Access Compliance Report

Public Rights-of-Way

(Curb Ramps)

Intersection ID: 51073	Main Street: RISBURG_LN	Cross Street: KEMPSFORD_DR	Location: W
ADA ID: BF72066F49DC	Ramp Type: PerpDiag	Initial Pass/Fail: Fail	Overall Compliance: No
Severity Score: 21.25			
Codes/Mitigation Info/Possible Solution		Field Measurements/Component Compliance

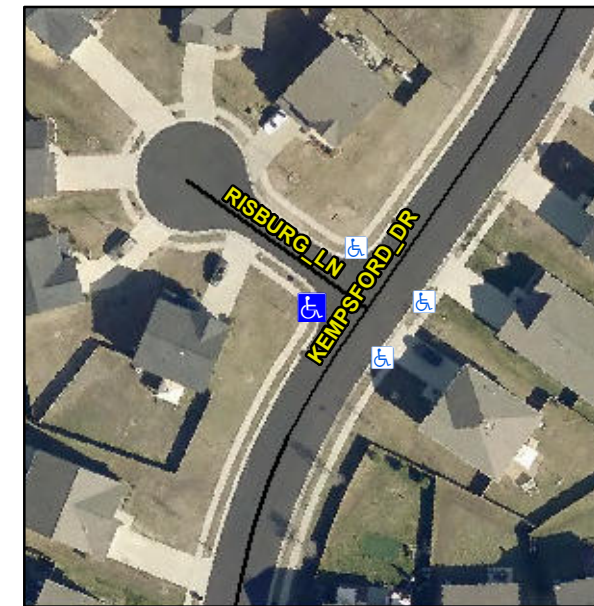
Not Found, R304.5.1, R304.2.2

Compliance	Description	Data	Compliance	Description	Data
N/A	Ramp Length (in)	47.0	No	Ramp Slope (%)	8.7
No	Ramp Width (in)	47.0	Yes	Ramp XSlope (%)	1.3
N/A	Flare Type LT	N/A	N/A	Flare Type RT	N/A
N/A	Flare Slope LT (%)	N/A	N/A	Flare Slope RT (%)	N/A
N/A	Flare Traversable LT?	N/A	N/A	Flare Traversable RT?	N/A
N/A	Landing Length (in)	N/A	N/A	DWS Provided?	N/A
N/A	Landing Width (in)	N/A	N/A	DWS Contrast?	N/A
N/A	Landing Slope (%)	N/A	N/A	DWS Length (in)	N/A
N/A	Landing X Slope (%)	N/A	N/A	DWS Full Width?	N/A
N/A	Landing Curb? (Y/N)	N/A	N/A	DWS Offset (in)	N/A
N/A	Shared Landing?	N/A			
N/A	Gutter Ponding?	N/A	N/A	Gutter Slope (%)	N/A
N/A	Gutter Lip Ht (in)	N/A	N/A	Gutter X Slope (%)	N/A
N/A	Painted X Walk1?	No	N/A	Painted X Walk2?	No
	X Walk 1 Direction	To SE		X Walk 2 Direction	To NE
N/A	X Walk 1 Width (in)	N/A	N/A	X Walk 2 Width (in)	N/A
	X Walk 1 Slope (%)	0.6		X Walk 2 Slope (%)	0.2
	X Walk 1 X Slope (%)	0.7		X Walk 2 X Slope (%)	0.6

Remove & Replace Curb Ramp With Two New Directional Ramps or Equivalent.
